## ADDENDUM NO. 2

**PROJECT NAME:** Wick Alumni Center Life Safety & HVAC Improvements  
**UNL PROJECT NUMBER:** C120P021  
**BID INVITATION NUMBER:** 2222-13-7200

**CONSULTANT:** Farris Engineering  
**ADDRESS:** 818 P Street, Suite 100

**DATE OF ISSUANCE:** September 11, 2013  
**DATE OF BID OPENING:** September 18, 2013

**SHEET NO**  
M2-1

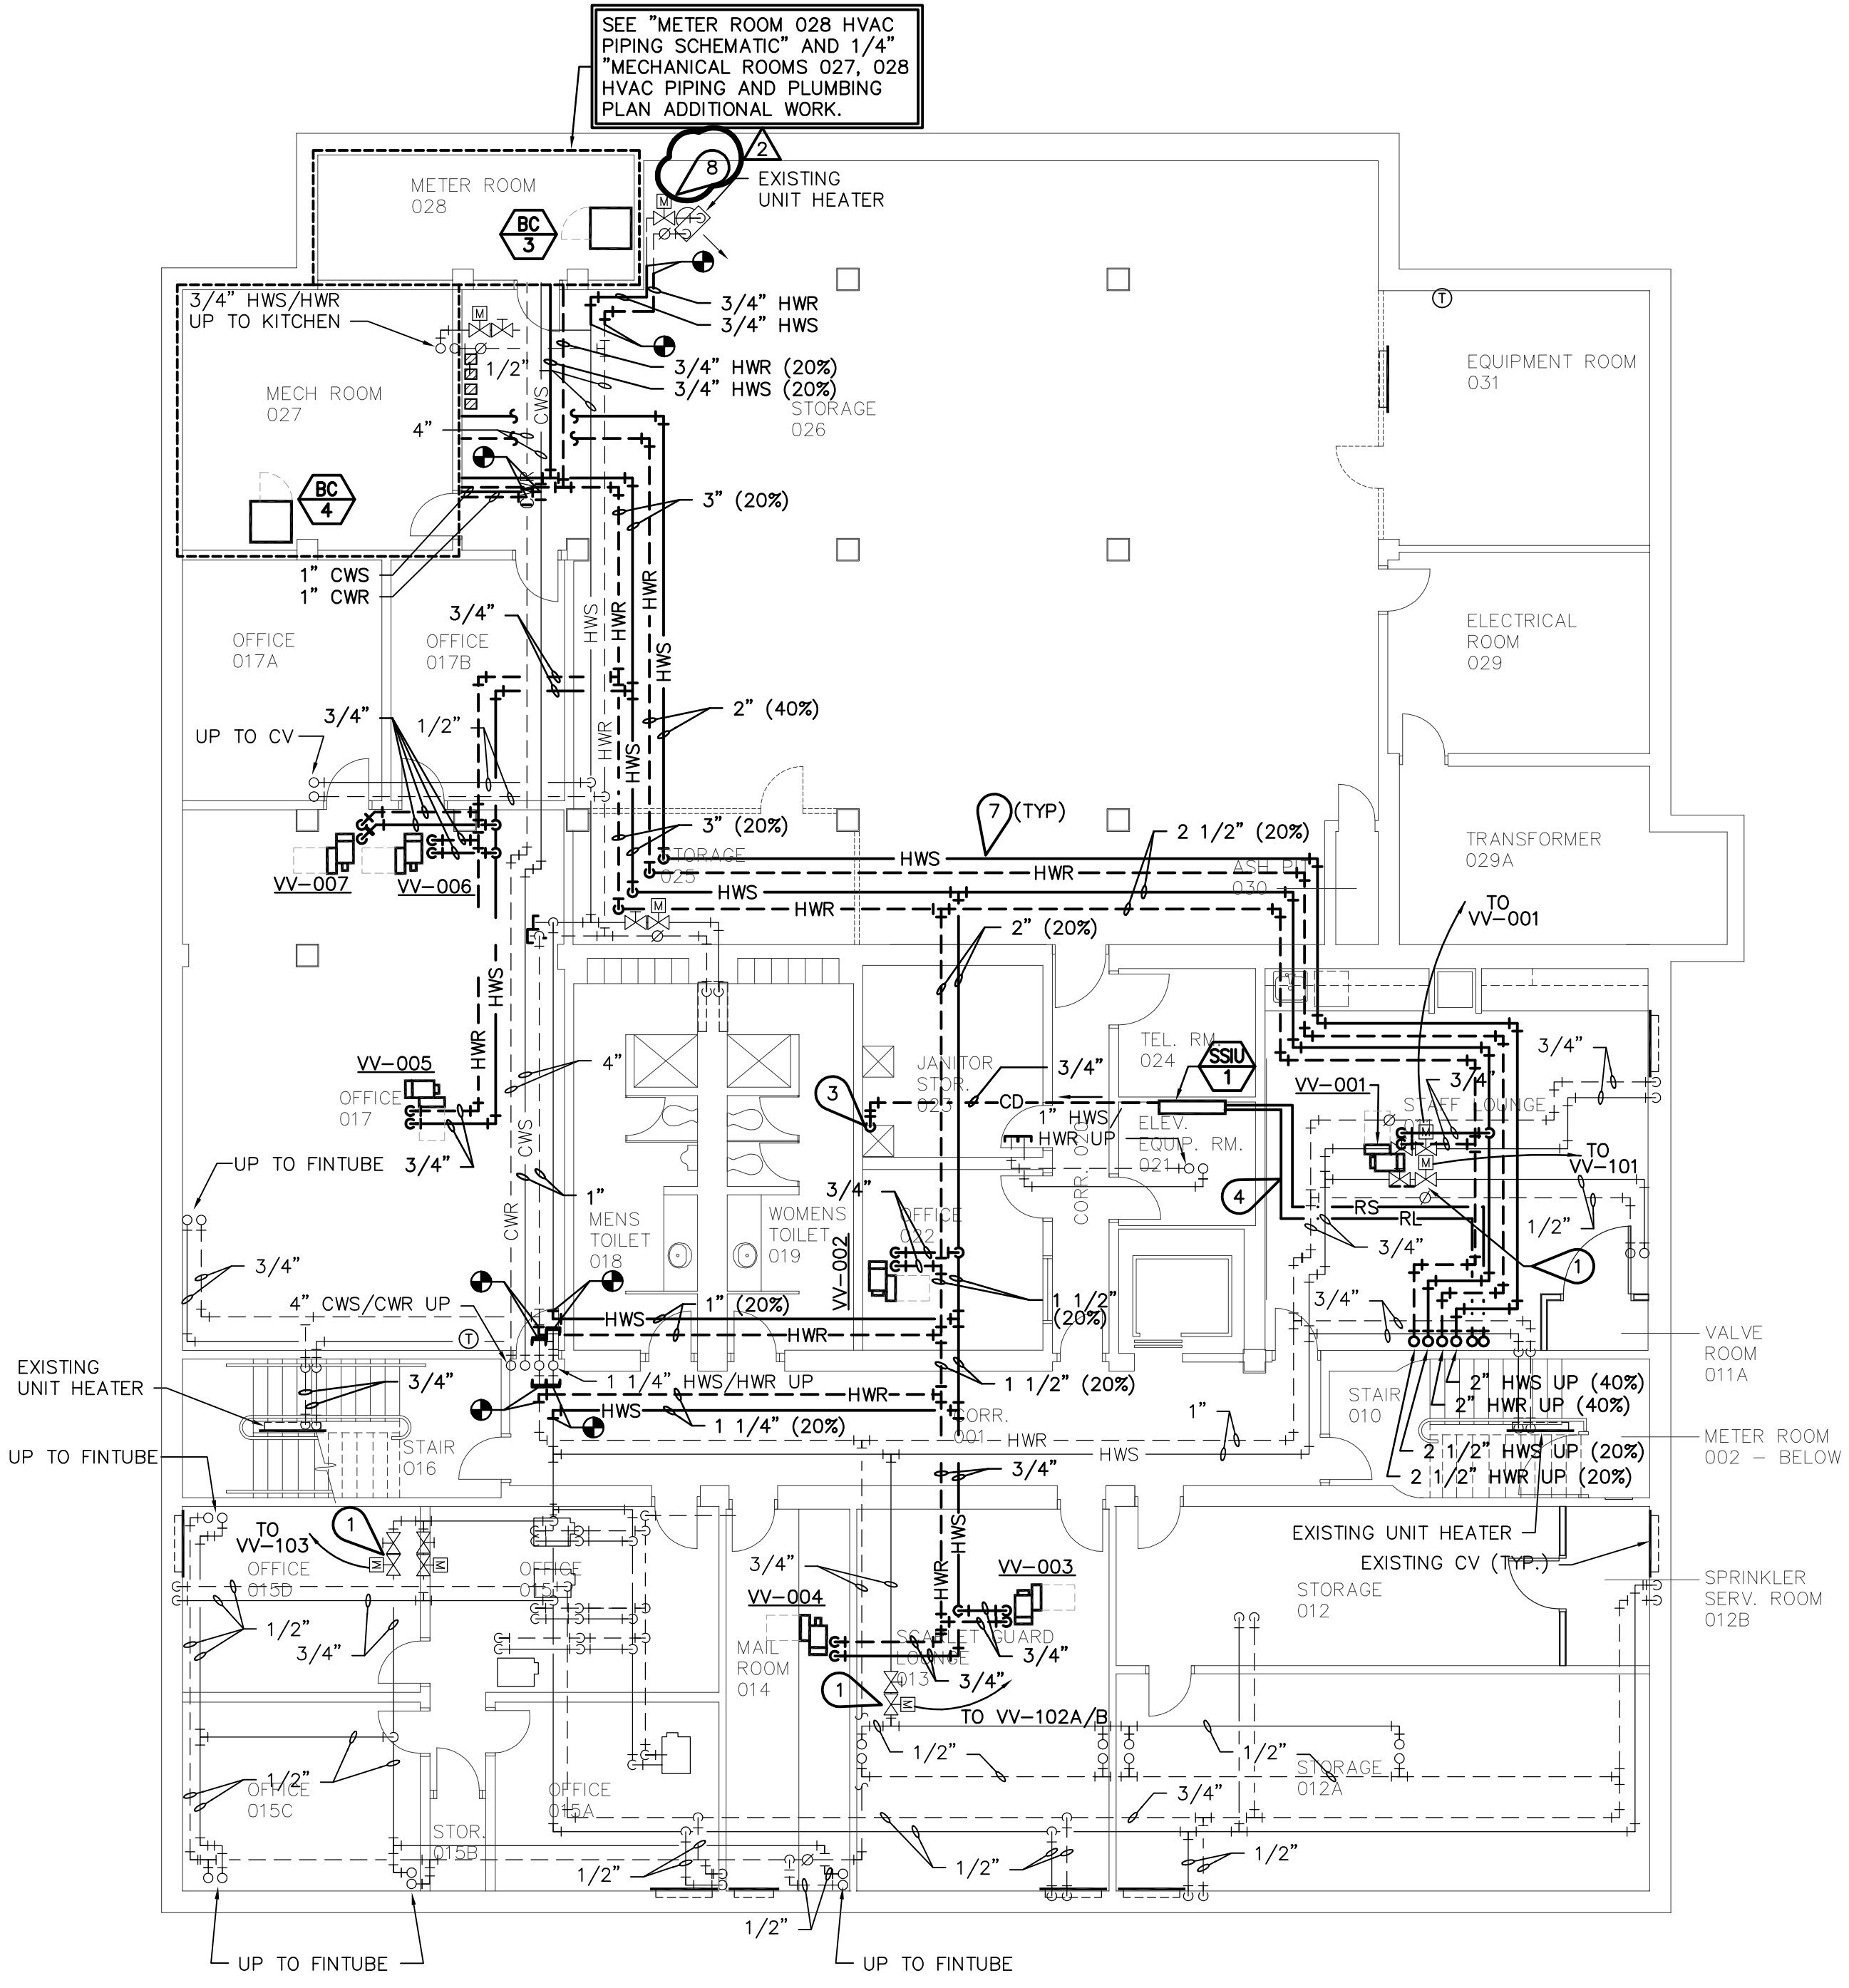
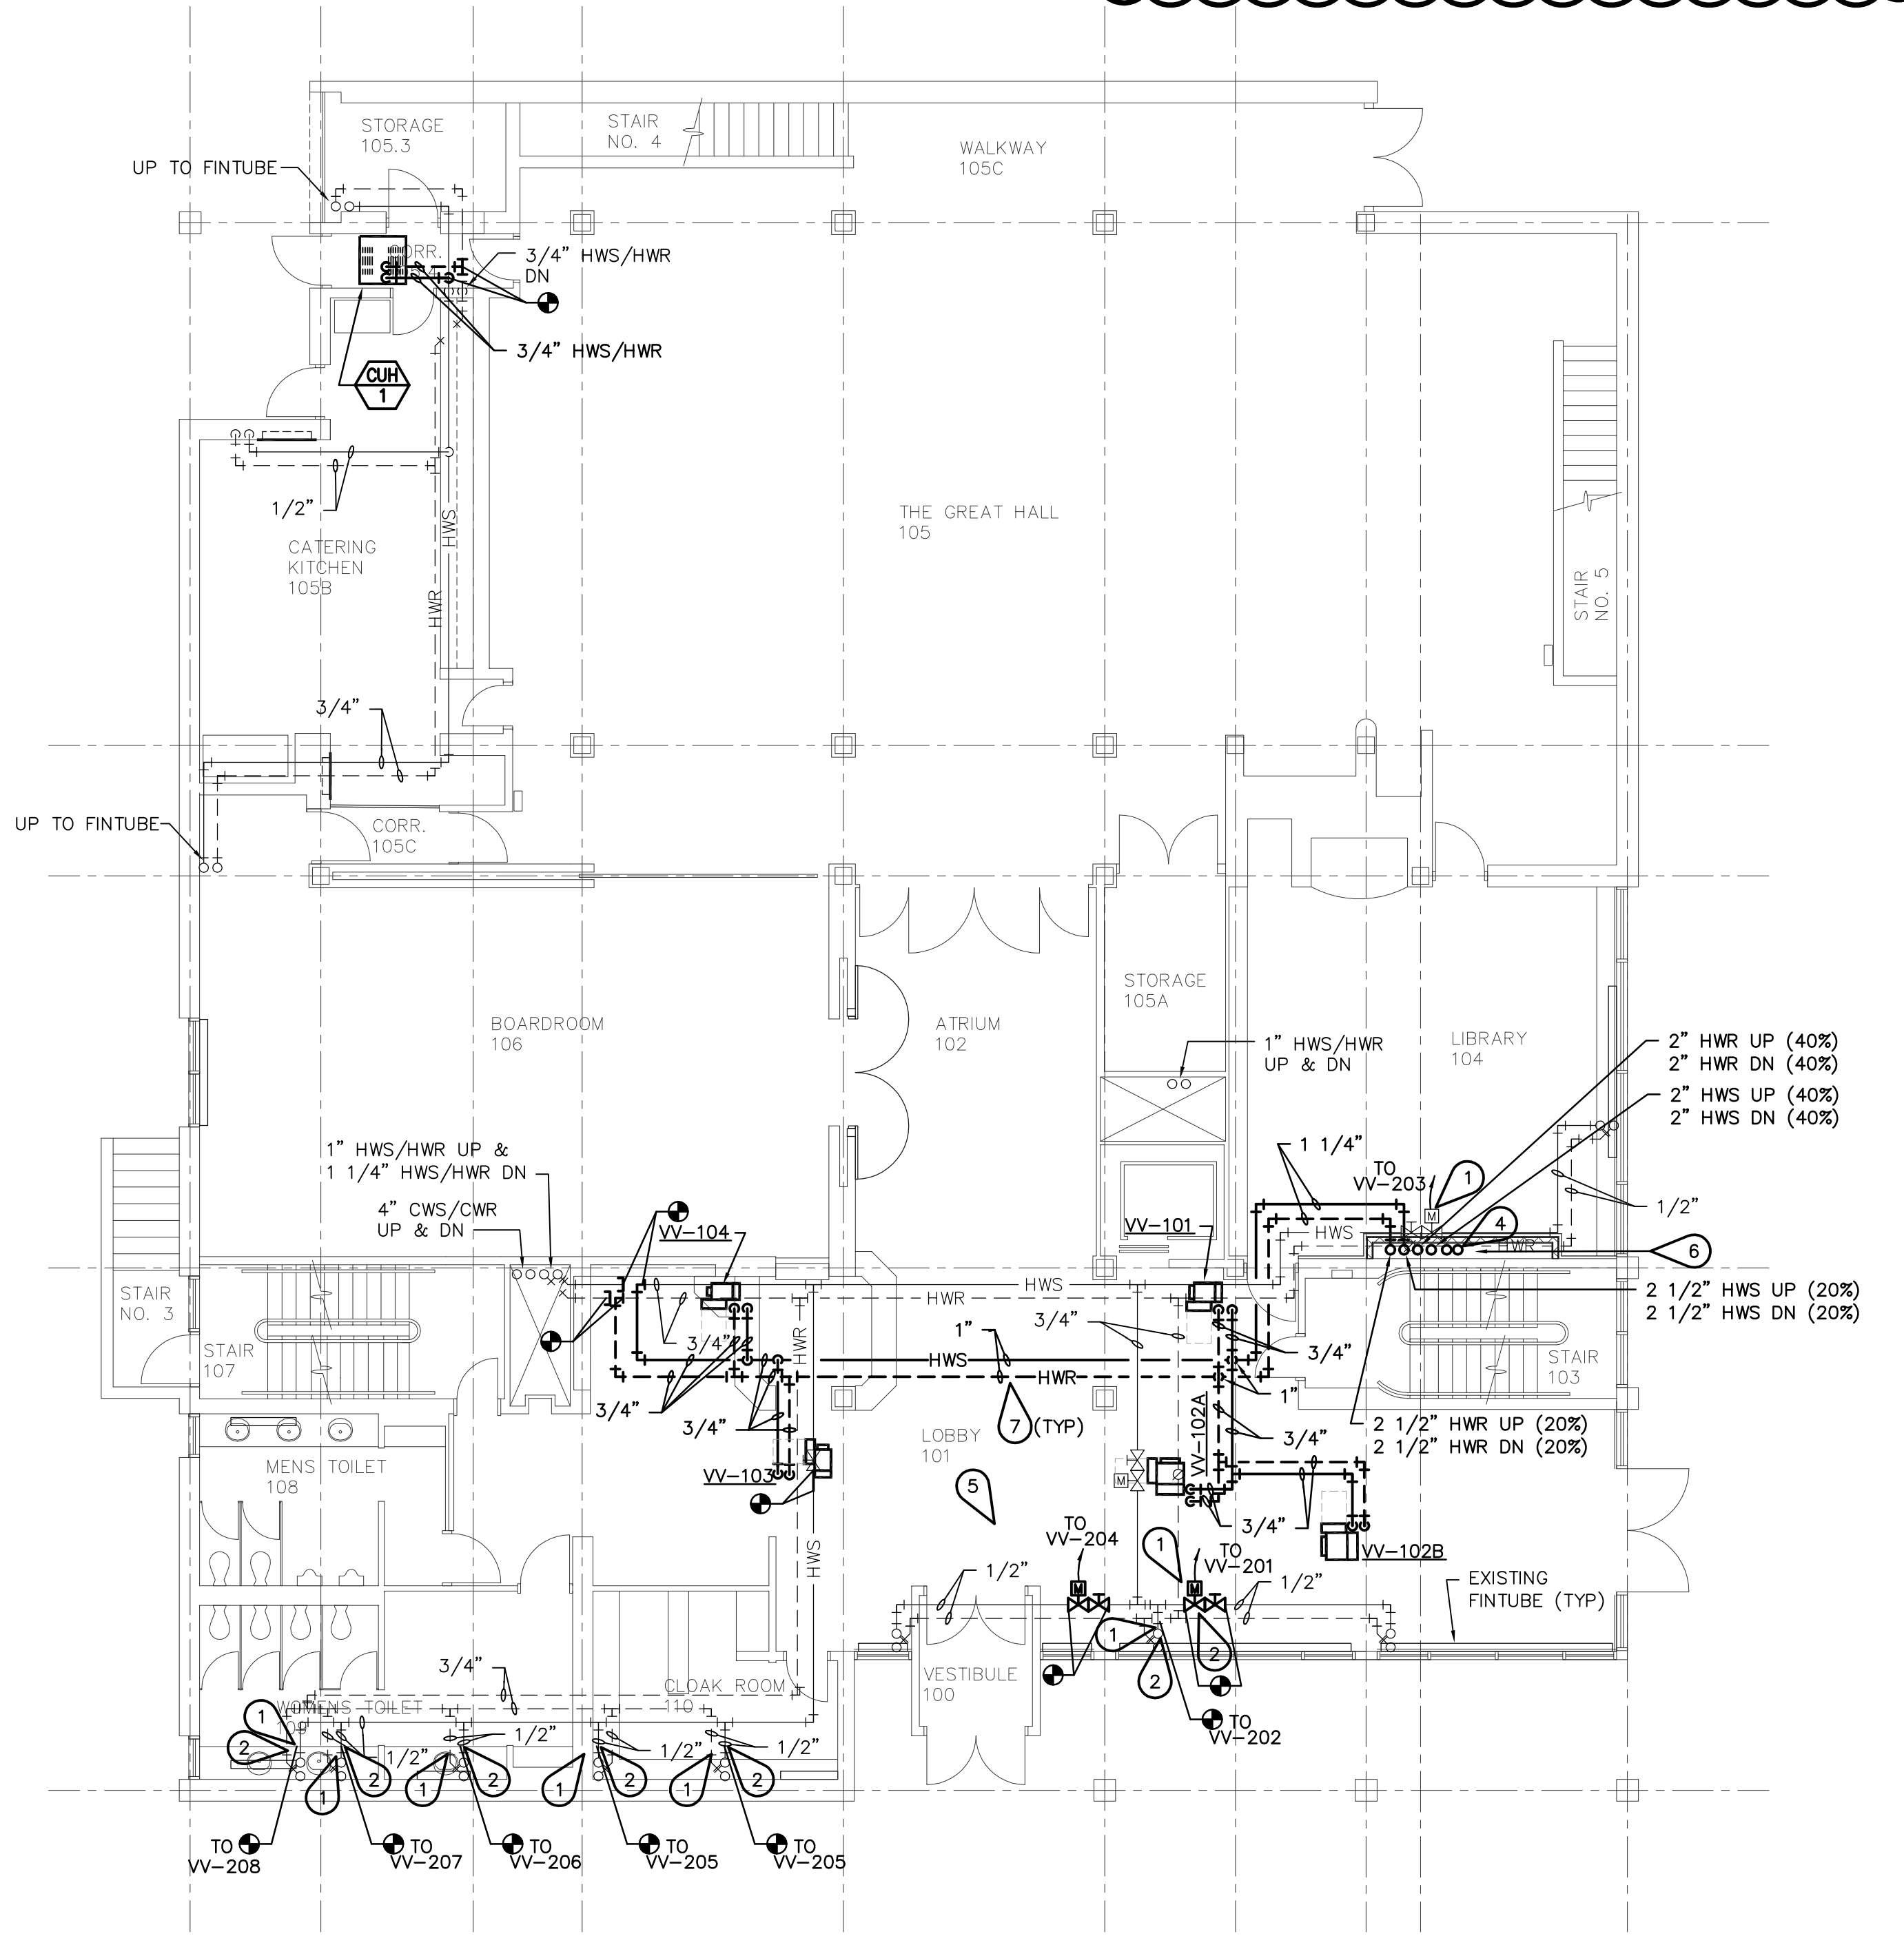
1. This sheet has been reissued in its entirety as a part of Addendum No.2.
2. Mechanical Keynote #8 has been added.

- 7 REFER TO PIPE INSULATION DETAIL 4/M5-2 (TYP).
  - 8 EXISTING PNEUMATIC CONTROL VALVES ON EXISTING UNIT HEATERS TO REMAIN SHALL BE REPLACED WITH NEW ELECTRONIC CONTROL VALVES, FURNISHED BY UNL BSM AND INSTALLED BY CONTRACTOR.
